## Library Construction Concerns – 4/2/2022

At the March 21, 2022 Library Board meeting, project manager Doug Landry presented the Board with a disc containing the 100% completed construction documents for the new library. The disc documents are in review by Parish Government, the Permits Department, Community Development, and the Fire Marshall. Mr. Landry suggested the Library Board review the documents also. The Library staff also reviewed the documents. The following document highlights several areas that require reconsideration and correction to avoid costly change orders after the bid is advertised and construction begins.

# Teen books

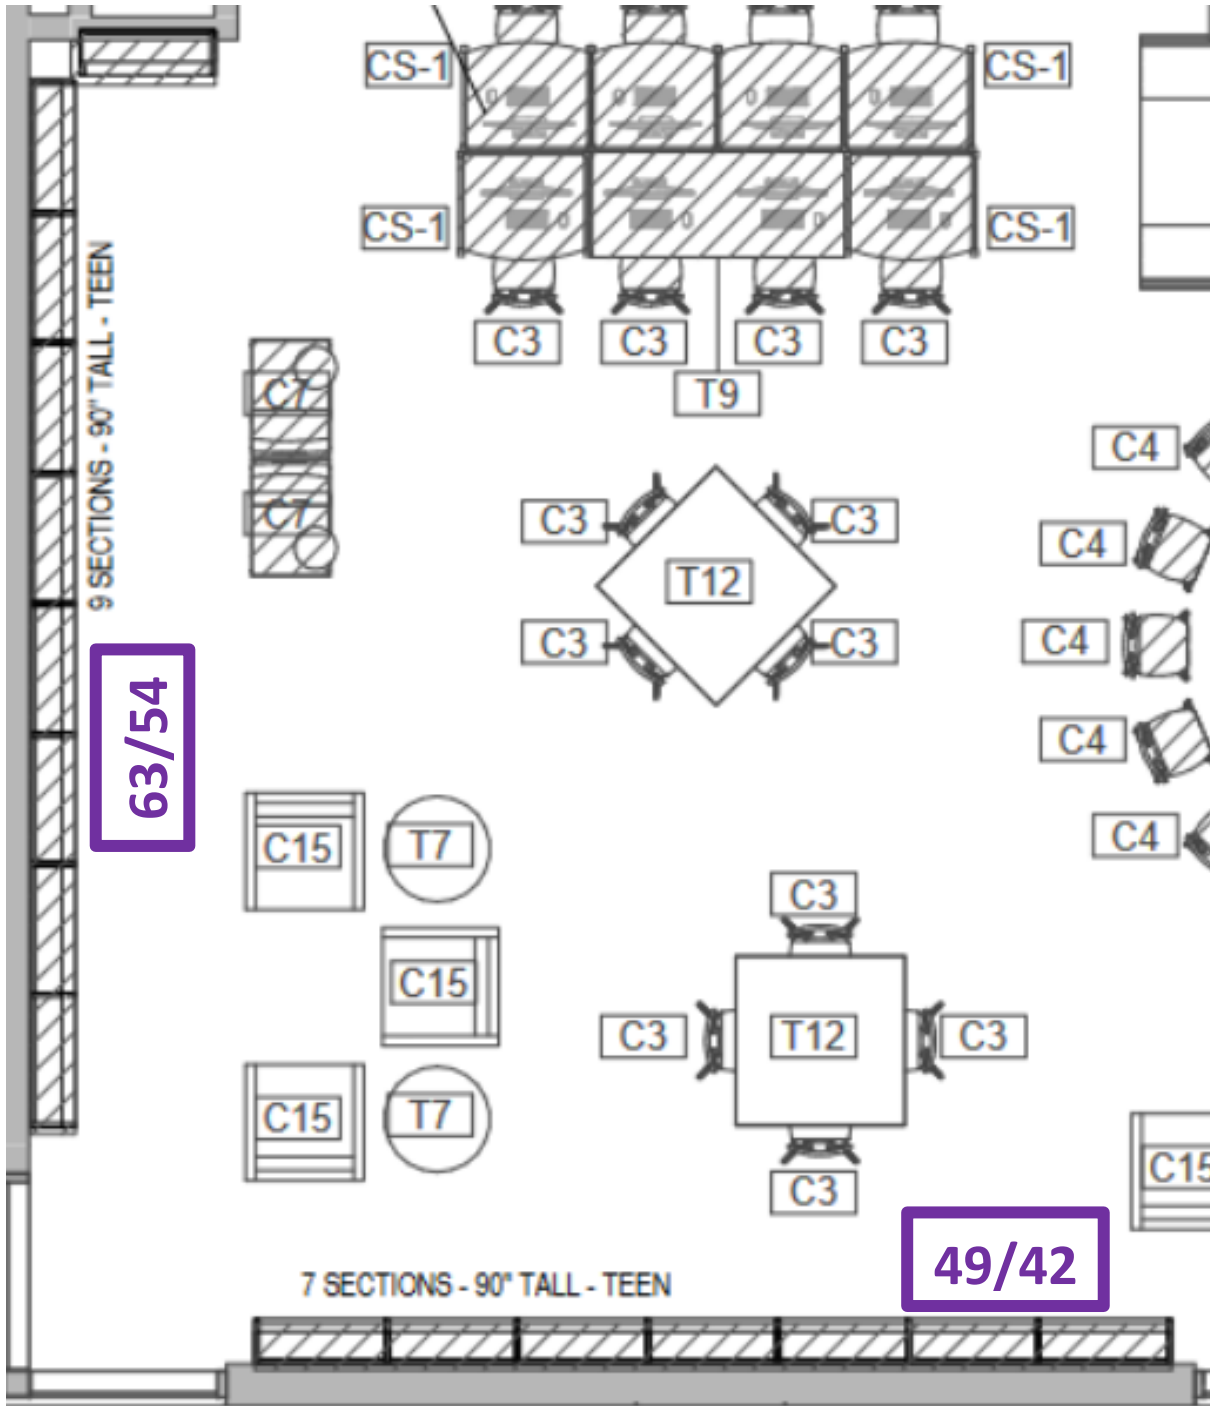
**IN ALL PROBABILITY IT WILL BE 96 SHELVES—THIS DOES NOT ALLOW FOR MUCH FUTURE GROWTH**
